7.0 Instrumentation and Control Systems

The information in this section of the reference ABWR DCD, including all subsections and tables, and figures, is incorporated by reference with the following departures and supplements.

Figure 7.1-1 SSLC Self-Test System

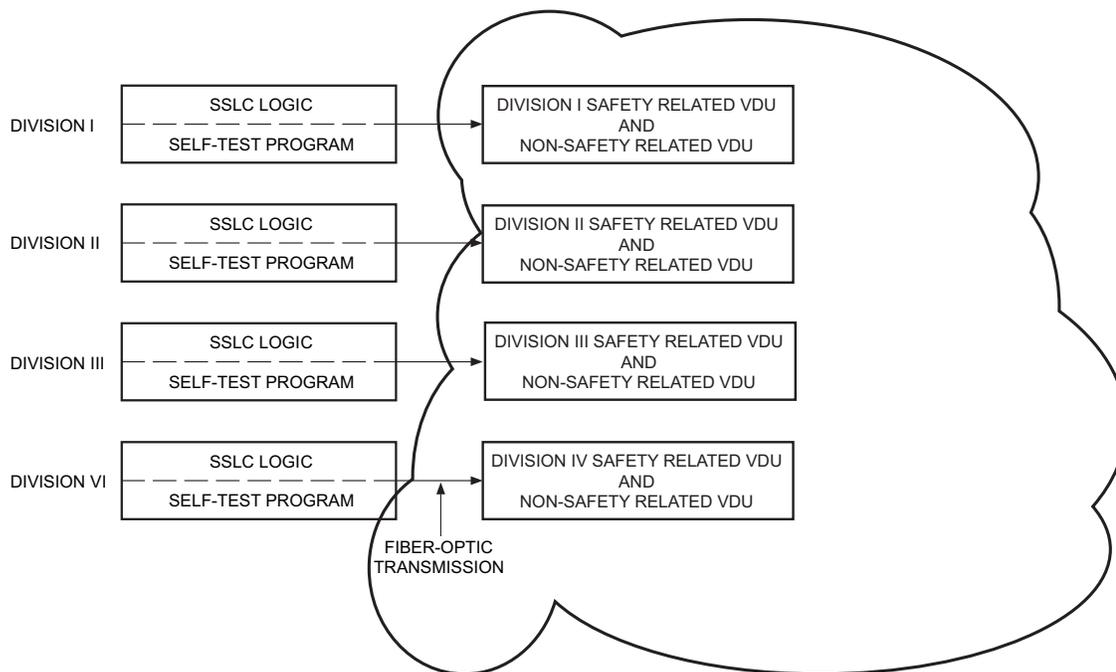
STD DEP T1 3.4-1 (Figure 7.1-1, 7.1-2)

STD DEP T1 3.4-1

The RPS and ESF Systems can be tested during reactor operation by six separate tests. The first five tests are primarily manual tests and, although each individually is a partial test, combined with the sixth test they constitute a complete system test. The sixth test is the self-test of the safety system logic and control which automatically tests the complete system excluding sensors and actuators.

- (4) *The fourth test checks calibration of analog sensor inputs at the analog inputs of the ~~remote multiplexing units~~. Remote Digital Logic Controllers (RDLCs). With a division-of-sensors bypass in place, calibrated, variable ~~ramp~~ signals are injected in place of the sensor signals and monitored ~~at the SSLC control room panels~~ for linearity, accuracy, fault response, and downscale and upscale trip response. ~~The test signals are adjustable manually from the control room and also are capable of performing an automatic sequence of events~~. When surveillance testing during plant shutdown, trip coincidence and actuated device operation can be verified by simultaneous trip tests of coincident channels. Pressure transmitters and level transmitters are located on their respective local panels. The transmitters can be individually valved out of service and subjected to test pressure to verify operability of the transmitters as well as verification of calibration range. To gain access to the field controls on each transmitter, a cover plate or sealing device ~~must~~ may be removed. Access to the field controls is granted only to qualified personnel for the purpose of testing or calibration adjustments.*

- (6) *The sixth test is an integrated self-test provision built into the microprocessors within the SSLC. It consists of an online, continuously operating, self-diagnostic monitoring network, and an offline semi-automatic (operator initiated, but automatic to completion), end-to-end surveillance program. Both online and offline functions operate independently within each of the four divisions. There are no multi-divisional interconnections associated with self-testing.*

The hierarchy of test capability is provided to ensure maximum coverage of all ~~EMS~~ ECE/SSLC functions, including logic functions and data communication links. Testing shall include:

Figure 7.1-2 Assignment of Interfacing Safety System Logic to SSLC Controllers

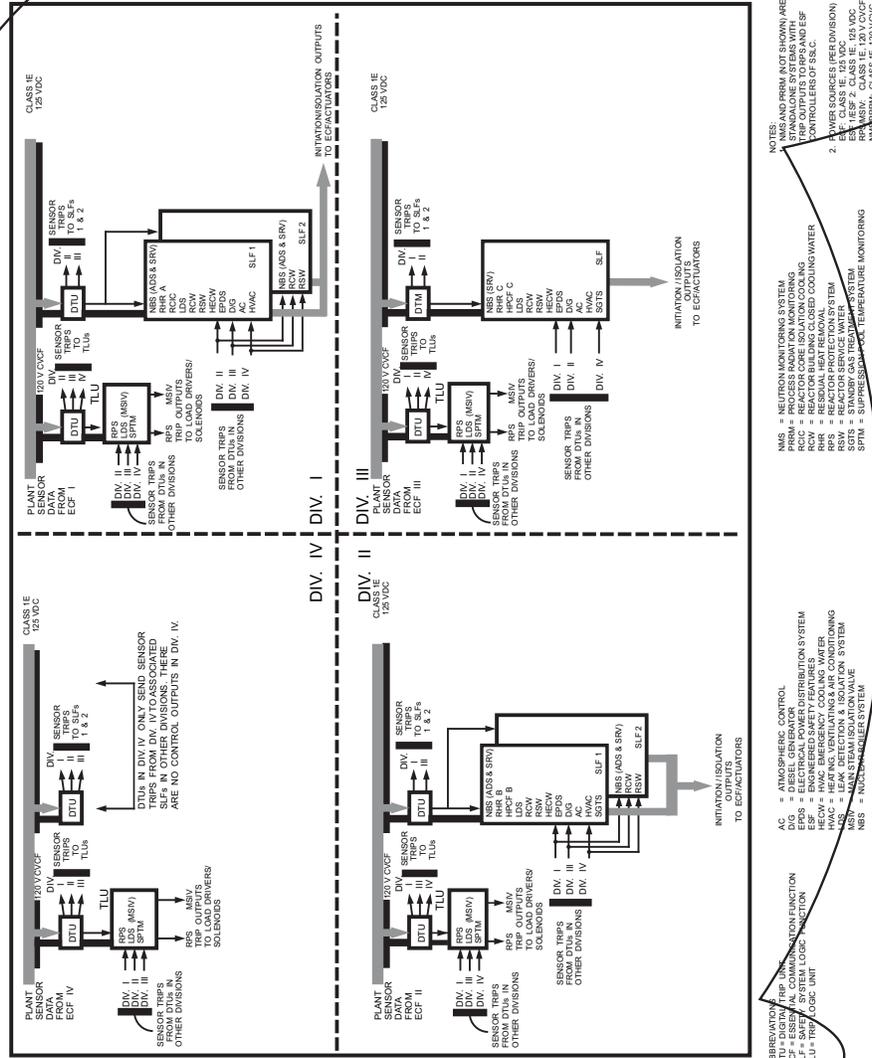
STD DEP T1 3.4-1

Divisional separation is also applied to the ~~essential multiplexing system (EMS)~~ Essential Communication Function (ECF) for Safety System Logic and Control (SSLC), which provides data highways for the sensor input to the logic units and for the logic output to the system actuators (actuated devices such as pump motors and motor-operated valves). Systems which utilize the SSLC are: (1) Reactor Protection (trip) System; (2) High Pressure Core Flooder System; (3) Residual Heat Removal System; (4) Automatic Depressurization System; (5) Leak Detection and Isolation System; (6) Suppression Pool Monitoring System; and (7) Reactor Core Isolation Cooling System. The equipment arrangement for these systems and other supporting systems is shown in Figure 7.1-2.
